MS9445
AMENDMENT 1
8 JULY 2003

MILITARY STANDARD

BOLT, MACHINE - STEEL AMS 6304, DIFFUSED NICKEL-CADMIUM PLATED,
HEXAGON HEAD, DRILLED, .500-20 UNJF-3AThis amendment forms a part of MS9445, dated 21 December 1962, and is approved for use by
all Departments and Agencies of the Department of Defense.

Sheet 1

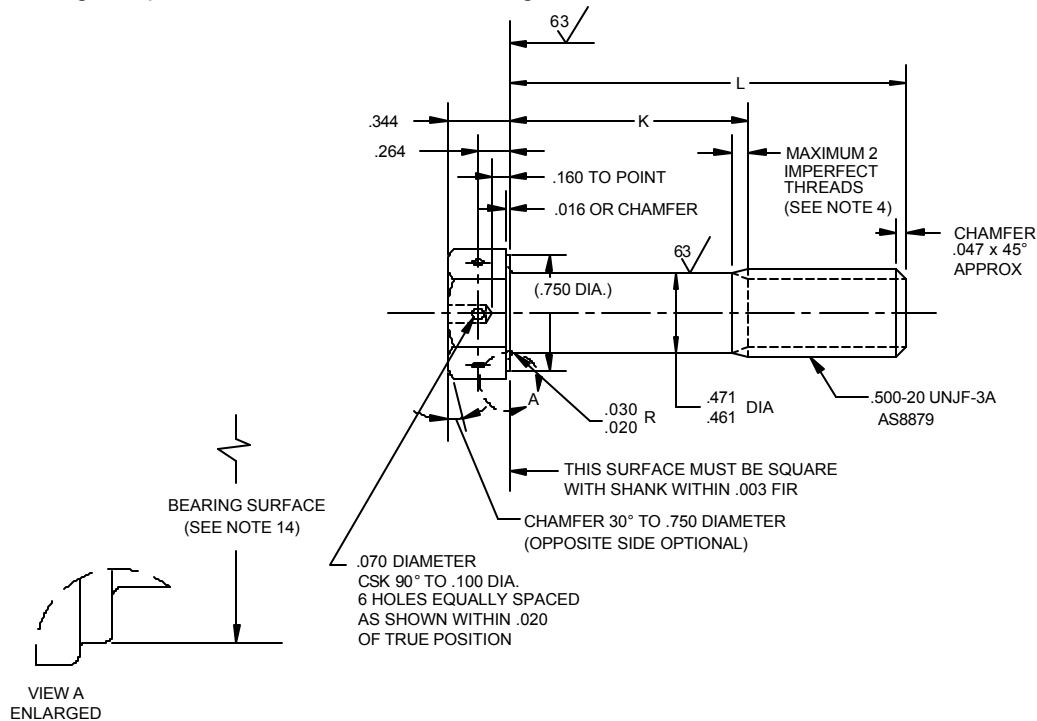
In drawing: Replace front view with this drawing and add View A.
